Planning Commission Staff Report

Petition: **P.Z. 22-2017 Clarkson Center (2264 Clarkson Road)**: A request for a zoning map amendment from a “R2” Residence District (15,000 square foot minimum) and “C-8” Planned Commercial to a “PC” Planned Commercial District for 0.9 acres located on the southern corner of the intersection of Clarkson Road and Clarkson Woods Drive. (20T610716).

REZONING APPLICATION: RESPONSES TO P.Z. 22-2017

2264 CLARKSON ROAD DEVELOPMENT

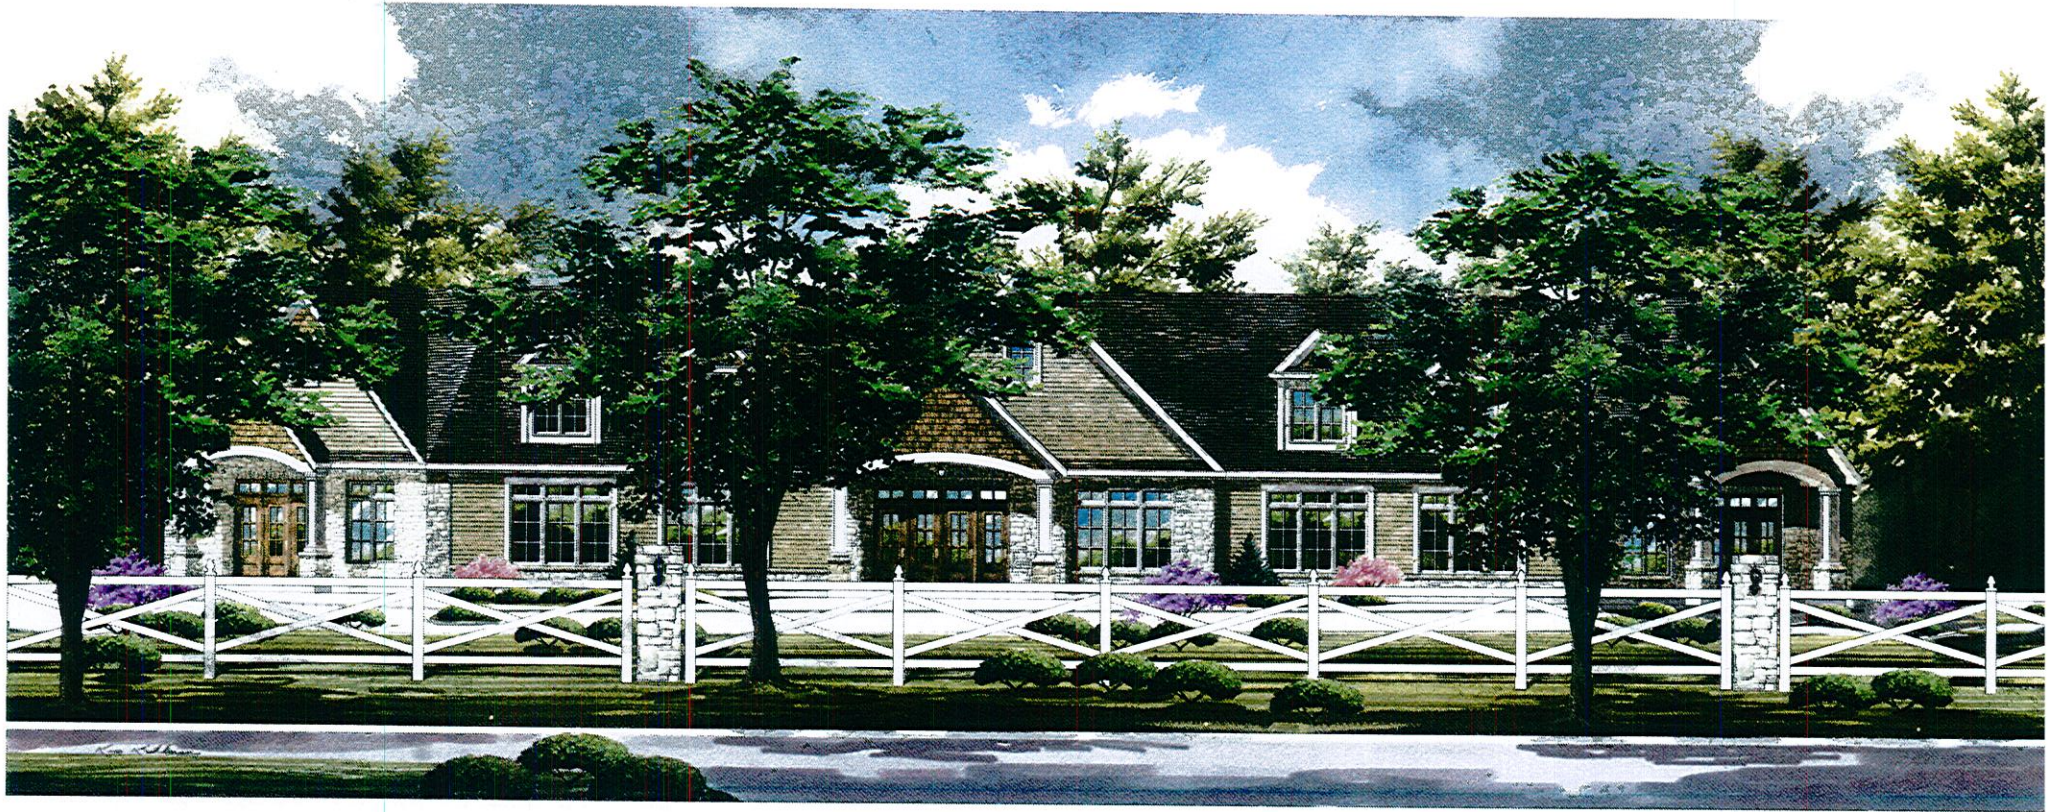
A preliminary drawing sketch of a proposed building was presented during the Public Hearing; there was significant concern regarding its ability to blend with the residential neighborhood. The Petitioner has provided a new rendering with his response letter that is more residential in character. The Preliminary Plan has section profiles for a 30' maximum building height. The rendering provided is for informational purposes to illustrate how the Petitioner plans to make the building more compatible with the adjacent residential properties. Architectural Elevations and renderings would be required as part of a Site Development Plan which would be reviewed by both the Architectural Review Board and the Planning Commission for approval.

Point 5. Appropriate building design: In the course of my first public meeting I presented a concept building design to demonstrate the quality of building that would be developed on site. Obviously, my design was considered too commercial looking for the residents of Clarkson Woods subdivision. Subsequently, I enlisted Lauren Strutman and her Architectural Design Group to help me redesign a building that appropriately complements the neighboring homes. I am including a copy of that new work Lauren has provided for your reference. The two views presented demonstrate the design without trees lining the road, while the second drawing depicts the site view with trees that already exist there. Further, I have committed to adding a limiting fence line that mirrors the Clarkson Woods fence line running along Clarkson Road. This latter action blends my development to the neighborhood and along with my existing trees and future plantings, helps to visually hide most of the parking lot proposed. [see attachment following text]

PRELIMINARY SITE + GRADING PLAN

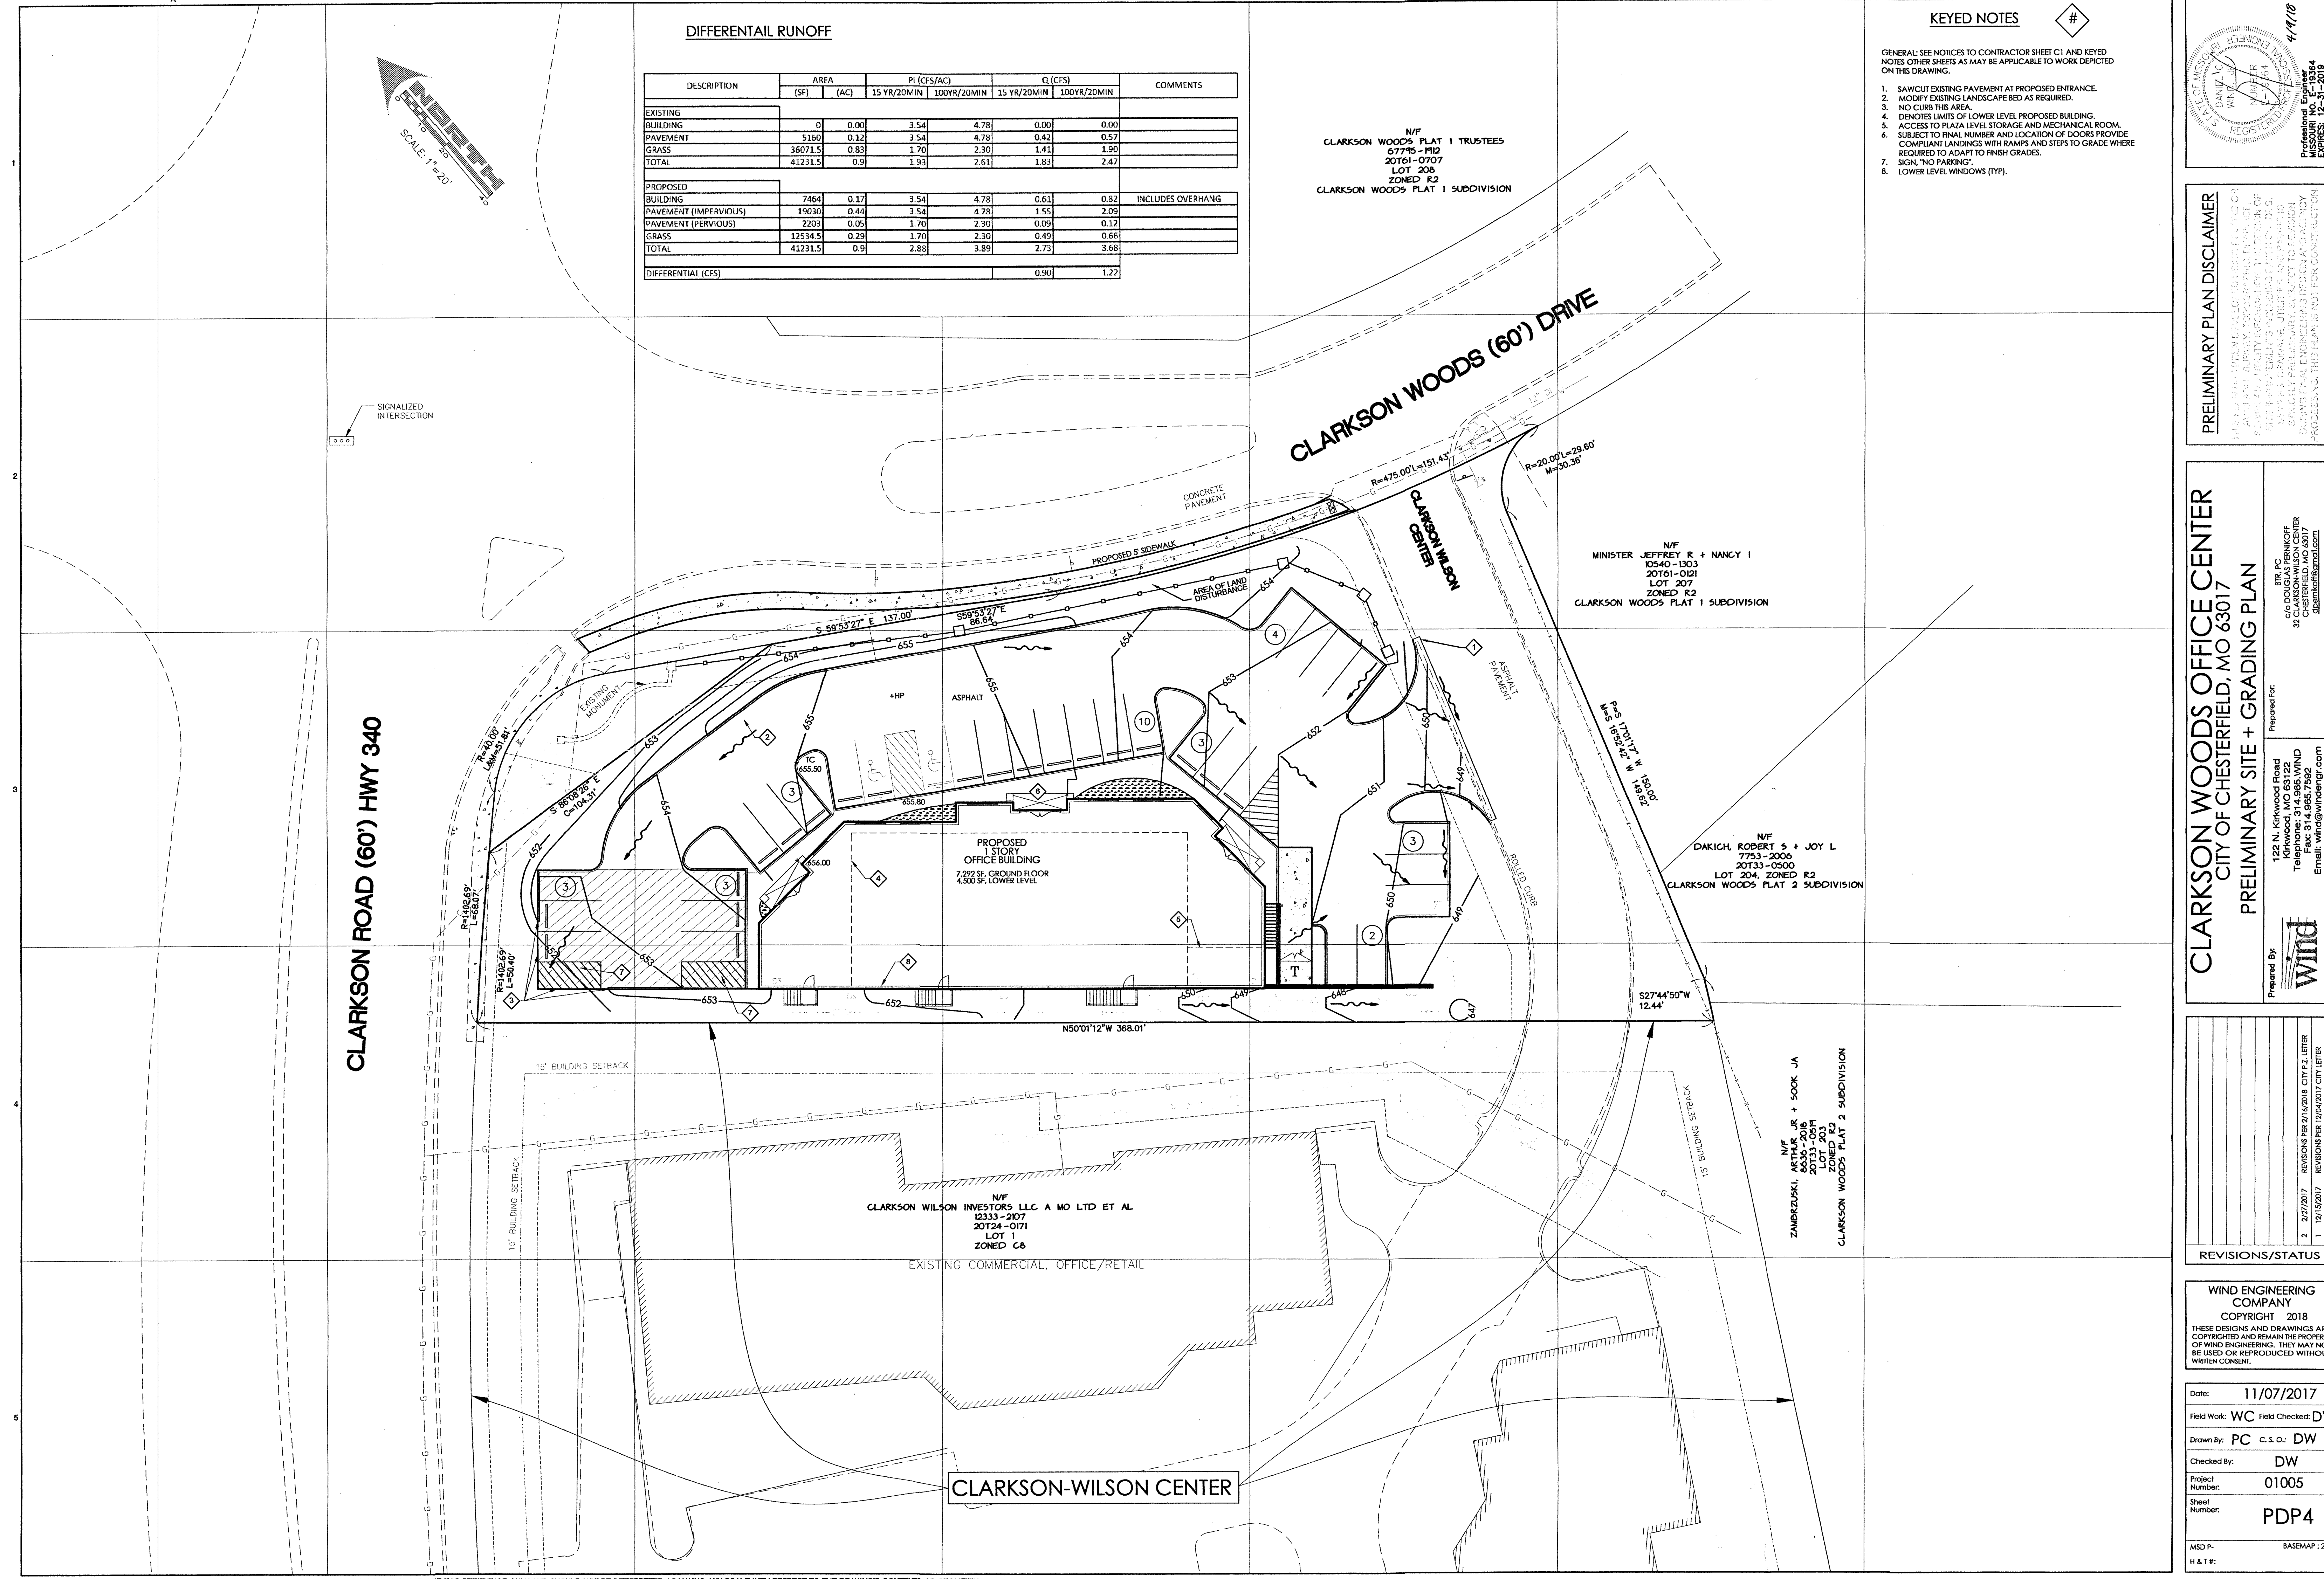
There were several concerns raised regarding the traffic and parking. The Petitioner has clarified the building will have a footprint of 7,644 square feet. The building will have a basement that will not be occupiable tenant space, which will bring the total square footage of the building to 12,000 square feet.

However the Unified Development Code states the parking requirements shall be calculated per the Gross Floor Area, which is the sum of the gross horizontal area of all floors of a building, including basement areas, as measured from the interior perimeter of exterior walls. As such, the parking regulations for this development will require, at minimum, between 3.3 and 4 parking spaces per 1,000 square feet of gross floor area. This calculation creates a minimum of 38 spaces and a maximum of 47 spaces.

The Petitioner will either need to reconfigure the parking layout to conform, or revise the square footage of the building. The applicant has stated in his response letter that he can design the building with or without a basement. If the applicant reduces the size of or eliminates the basement portion of the building, the Petitioner will be able to comply with the parking regulations of the Unified Development Code. The Unified Development Code and Attachment A have minimum open space requirements, stormwater management standards, and landscaping requirements the Site Development Plan will have to comply with in addition to parking standards. Ultimately, these development standards and the available space on the lot will limit the building size. The Petitioner may have to make the building smaller in order to fully comply with all development standards.

There were several concerns regarding the flow of traffic past this site on the existing drive aisle. The Petitioner stated he was amenable to adding traffic control measures as necessary, and has added a stop sign at the intersection of the drive aisle and Clarkson Woods Drive to the Preliminary Plan.

- a. Our parking requirements fit the UDCPR for a 7500 s.f. building. The addition of a basement would serve for storage, mechanical & other internal use.
- b. Ms. Yeomans, MDOT representative for West County, has provided the City a letter emphasizing that the development in question will NOT impose any undue traffic enhancement.
- c. At the prior meeting, one of the P&Z Board members suggested a stop sign be placed at the north end of the easement road, along with a white line along the midline. I am happy to comply with this suggestion as it makes sense to add a stop exiting the commercial center.
